**TENNESSEE VALLEY AUTHORITY
SEQUOYAH NUCLEAR PLANT
UNITS 1 AND 2**

**ANP-3053(NP), Revision 4, Sequoyah HTP Fuel Transition –
NRC RAIs and Responses, June 2012
(Non-Proprietary Version)**

**Sequoyah HTP Fuel Transition –
NRC RAIs and Responses**

Figure 4: Updated Core Safety Limit Lines for Sequoyah Technical Specifications

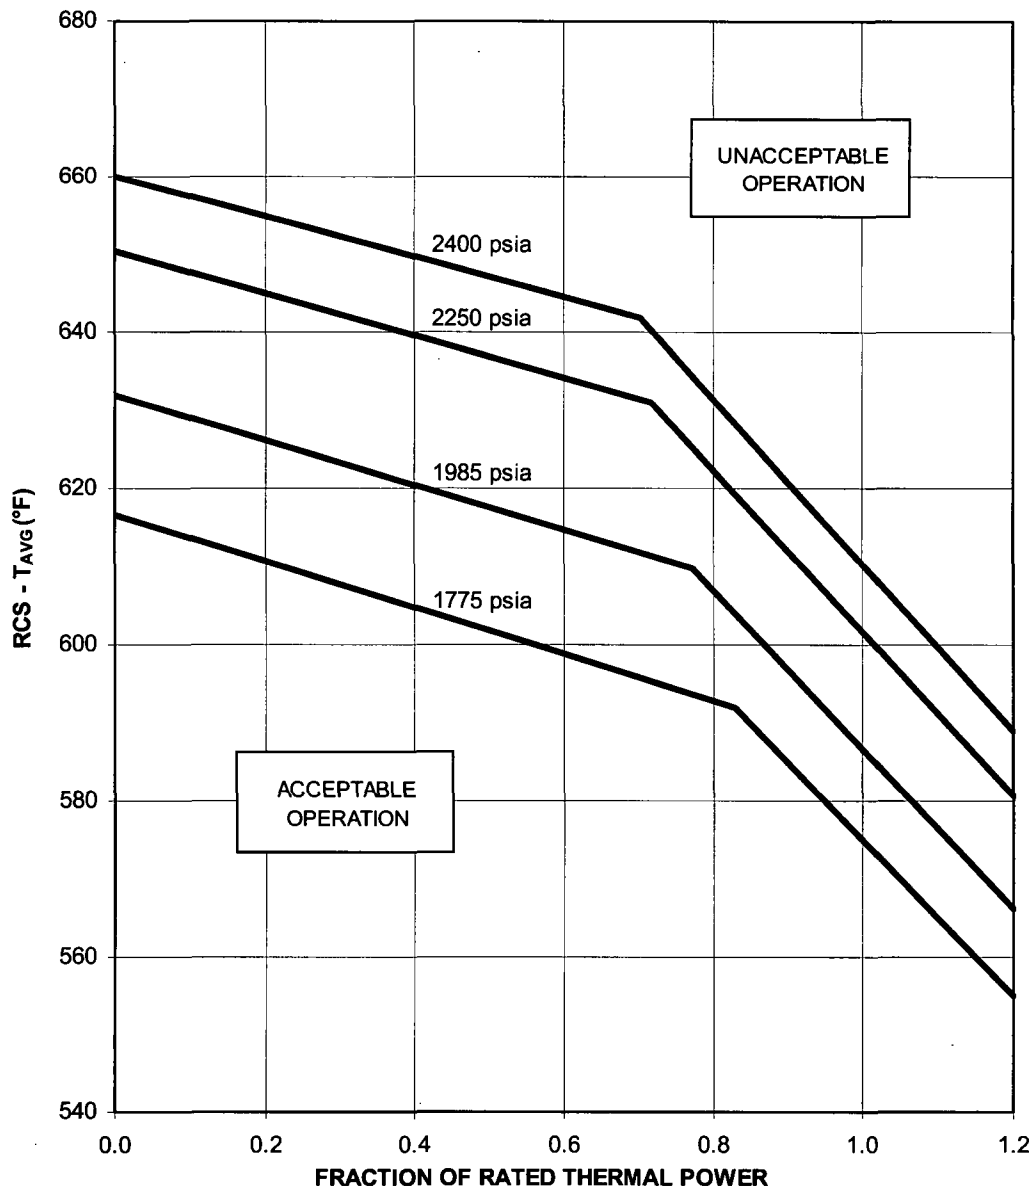
Provide a detailed description with respect to the applicability of all the approved methodologies listed in the proposed TS 6.9.1.14.a to the AREVA Advanced W17 HTP fuel design.

As a result of these changes, the core safety limit lines shown in Figure 2.1-1 of the SQN Units 1 and 2 Technical Specifications will be modified to represent the protected OT Δ T trip limit lines and are shown in Figure 4 below.

The revised CSL lines generated for the Adv. W17 HTP fuel design at the higher reactor coolant flow rate were evaluated against the Mark-BW CSL lines at the current reactor coolant flow rate, and it was shown that the CSL lines shown in Figure 4 are applicable to both fuel designs resident in the SQN Units 1 and 2 cores. Therefore, Figure 4 is applicable for use in the SQN Units 1 and 2 Technical Specifications.

Figure 20: Representative Illustration of RTM and DNBR Penalties Applied Against the RTM

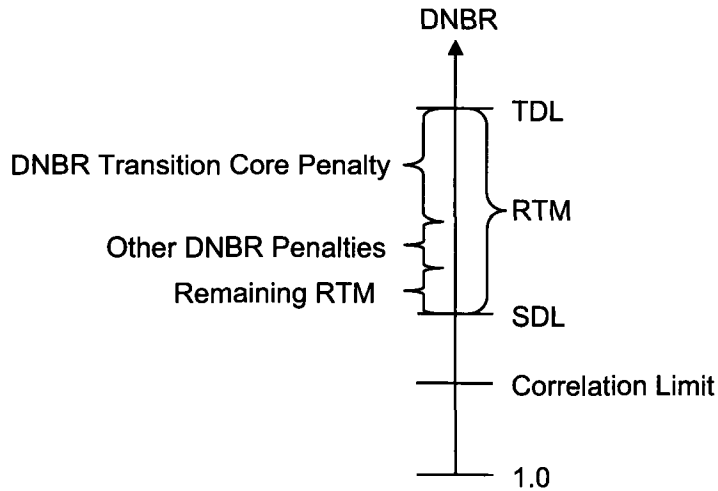
The June 17, 2011, submittal stated that the thermal hydraulic analysis indicates that the transition from a full core of Mark-BW fuel to a full core of Advanced W17 HTP fuel will result in a small increase in bypass flow and a small decrease in the RCS loop flow due to the higher pressure drop of the Advanced W17 HTP fuel. It also stated that the combined effect of the fuel transition and the steam generator replacement is a small net increase in RCS loop flow. Based on the reason above, TVA requested to revise the design flow rate shown in Table 2.2-1 and Figure 3.2-1. Please provide: (1) the rationale for a small net increase in RCS loop flow due to the combined effect of the fuel transition and the steam generator replacement; (2) how to obtain or to generate the data for design flow rate of 91,400 GPM in Table 2.2-1 and total RCS flow rate of 378,400 GPM at 100% Thermal Power Fraction (TPF) and 359,480 GPM at 90% TPF in Figure 3.2-1, respectively; and (3) justification for proposed 5% RCS flow rate increase.

The purpose of the RTM is to provide the flexibility to accommodate cycle specific impacts on the DNBR analyses. Whenever any change is made to the fuel assembly or cycle design, if there is a transition core penalty, or if some non-conservatism is discovered, the impact of the change can be quantified and assessed against the RTM. The RTM can account for many different penalties which account for changes in DNB-based calculations which cover all operating conditions. If the remaining RTM is greater than or equal to zero after all penalties have been considered, then the existing DNB calculations and MAP limits are considered acceptable. The remaining RTM is

calculated each cycle for each fuel type present within the core. A representative diagram illustrating RTM (including a transition core penalty) is given below in Figure 20.
